**MEMORANDUM**

REVIEW TYPE: **Site Plan Review**
 CASE #: **820060160**
 PROJECT NAME: Danshes Property
 APPLYING FOR: Approval of 40 dwelling units including 34 one-family detached dwelling units and six MPDUs (townhouses) on 92 acres of land in the RNC Zone.

REVIEW BASIS: Div. 59-D-3 of Montgomery County Zoning Ordinance
 ZONE: RNC
 LOCATION: Located on the east side of Brooke Road, approximately 500 feet north of the intersection with Olney Sandy Spring Road (MD 108)

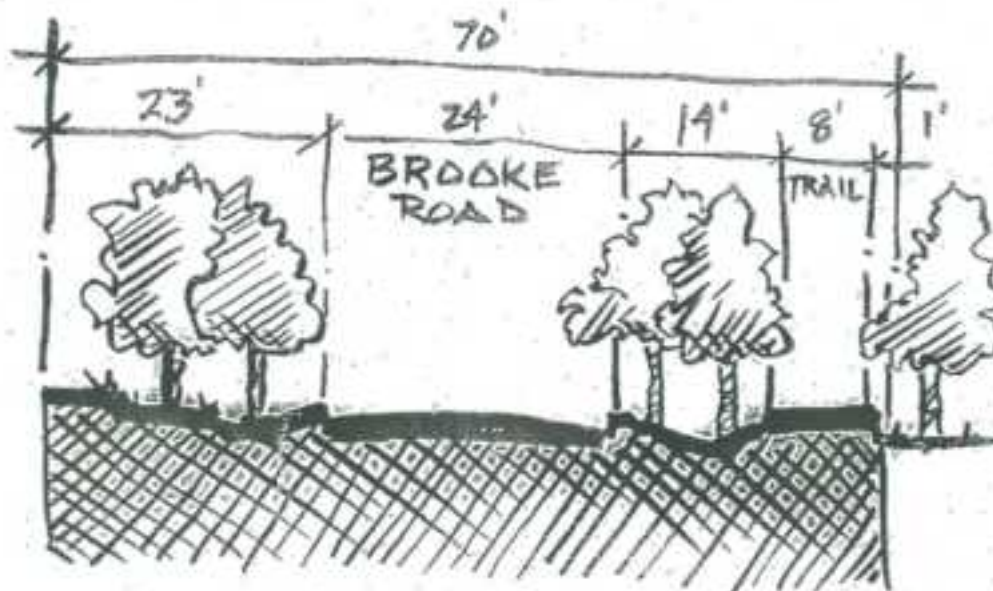
The cross-section shown below is recommended for Brooke Road. It features landscaping on either side of an 8' asphalt trail to create a sense of enclosure and to provide a natural setting.
